Access Compliance Report

Public Rights-of-Way

(Curb Ramps)

Intersection ID: 25141	Main Street: PINEVILLE-MATTHEWS_RD	Cross Street: RIDGELOCH_PL	Location: NW
ADA ID: 23C9093C8A4A	Ramp Type: PerpDiag	Initial Pass/Fail: Fail	Overall Compliance: No
Severity Score: 25			
Codes/Mitigation Info/Possible Solution		Field Measurements/Component Compliance

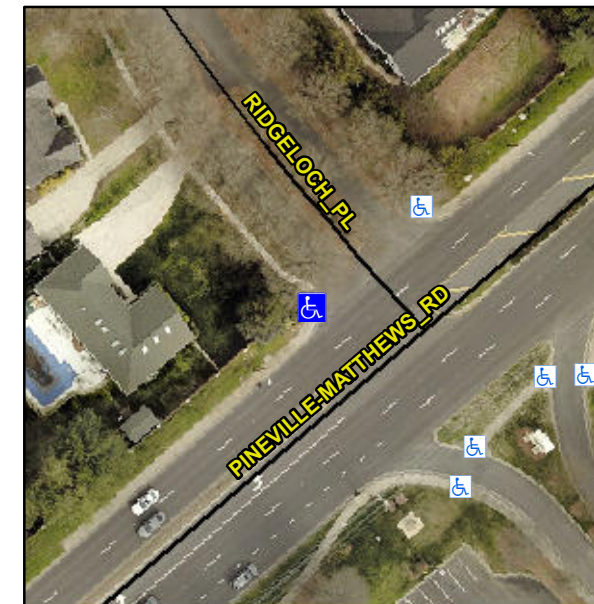
Not Found, R304.2.2, R304.5.3

Compliance	Description	Data	Compliance	Description	Data
N/A	Ramp Length (in)	61.0	No	Ramp Slope (%)	11.3
Yes	Ramp Width (in)	48.0	No	Ramp XSlope (%)	6.3
N/A	Flare Type LT	N/A	N/A	Flare Type RT	N/A
N/A	Flare Slope LT (%)	N/A	N/A	Flare Slope RT (%)	N/A
N/A	Flare Traversable LT?	N/A	N/A	Flare Traversable RT?	N/A
N/A	Landing Length (in)	N/A	N/A	DWS Provided?	N/A
N/A	Landing Width (in)	N/A	N/A	DWS Contrast?	N/A
N/A	Landing Slope (%)	N/A	N/A	DWS Length (in)	N/A
N/A	Landing X Slope (%)	N/A	N/A	DWS Full Width?	N/A
N/A	Landing Curb? (Y/N)	N/A	N/A	DWS Offset (in)	N/A
N/A	Shared Landing?	N/A			
N/A	Gutter Ponding?	N/A	N/A	Gutter Slope (%)	N/A
N/A	Gutter Lip Ht (in)	N/A	N/A	Gutter X Slope (%)	N/A
N/A	Painted X Walk1?	No	N/A	Painted X Walk2?	No
	X Walk 1 Direction	To SE		X Walk 2 Direction	To NE
N/A	X Walk 1 Width (in)	N/A	N/A	X Walk 2 Width (in)	N/A
	X Walk 1 Slope (%)	3.3		X Walk 2 Slope (%)	0.5
	X Walk 1 X Slope (%)	0.1		X Walk 2 X Slope (%)	3.8

Remove & Replace Curb Ramp With Two New Directional Ramps or Equivalent.
